Express Mail Label No. EV676907750US
U. S. Patent Application No. 09/788,179
Amendment Dated July 12, 2006
Reply to Office Action Dated March 2, 2006

Amendments to the Drawings

FIG. 2

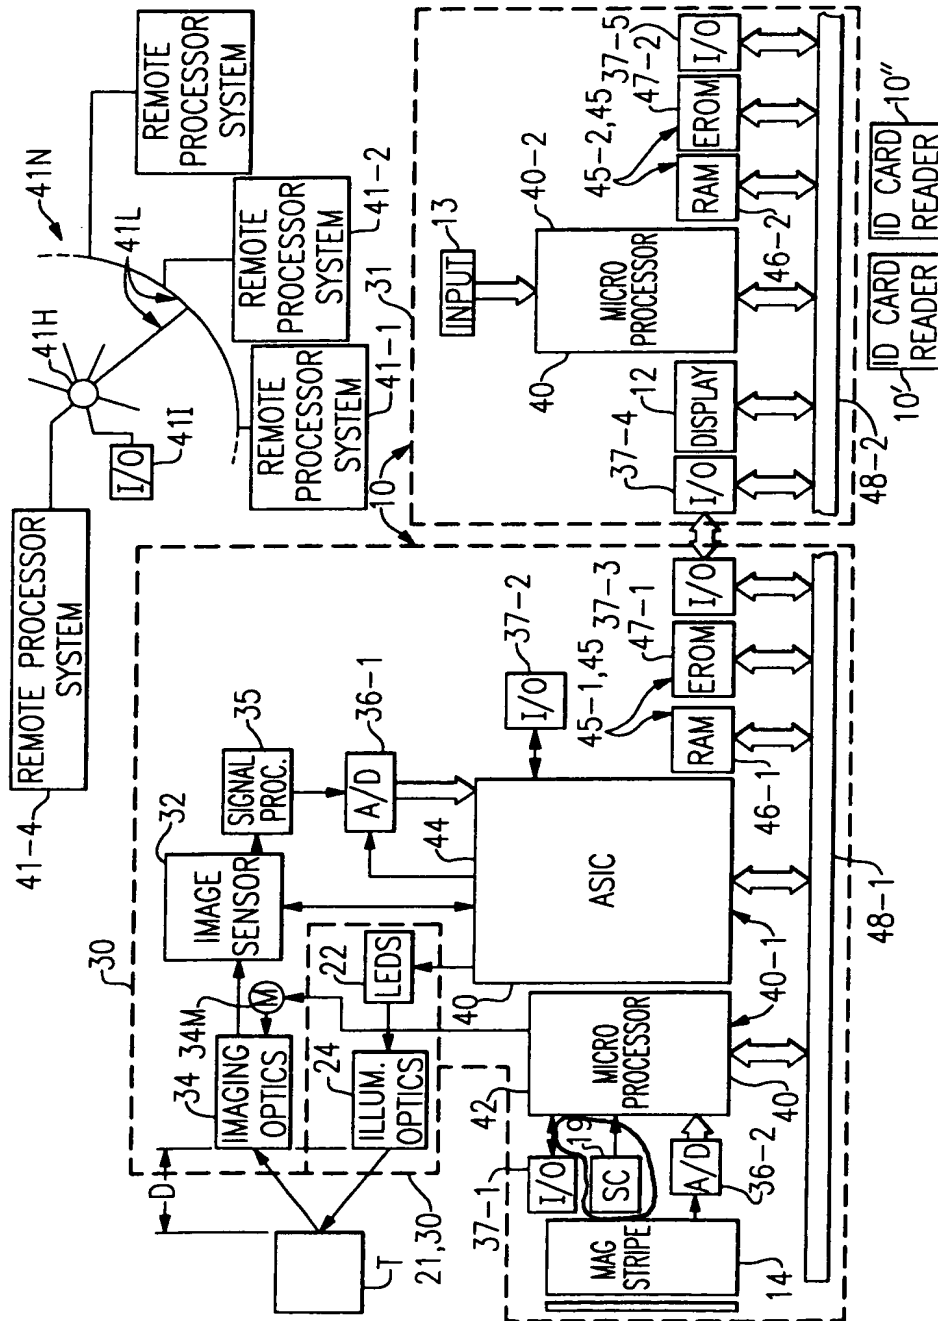
The attached Fig. 2 includes changes. In Fig. 2, smart card 19 has been added.

magnetic stripe reader 14 “that allows decoding of magnetic stripe reading information from identification card 16 in the case the card includes a magnetic stripe.” Also, there is described at page 10, lines 11-14 that “Processor 42 may also receive electrical signal information from magnetic stripe reader 14 as digitized by A/D converter 36-2. Processor 42 is described in an exemplary embodiment as part of control circuit 40 (see *e.g.*, Fig. 2). The description also provides support for a communication between the control circuit and a card reader where the card reader is not optical based or mag stripe based. For example, the specification states processor 42 may also receive electrical signals from a smart card reader (not shown), or another data input source. (page 10, lines 12-14). Applicants have amended Fig. 2 so that Fig. 2. includes a depiction of a smart card reader in communication with processor 42 as described in the written description so that the drawings are brought into greater conformity with the written description. Also, p. 10 is amended to include a reference to a smart card reader 19, as shown in Amended Fig. 2.
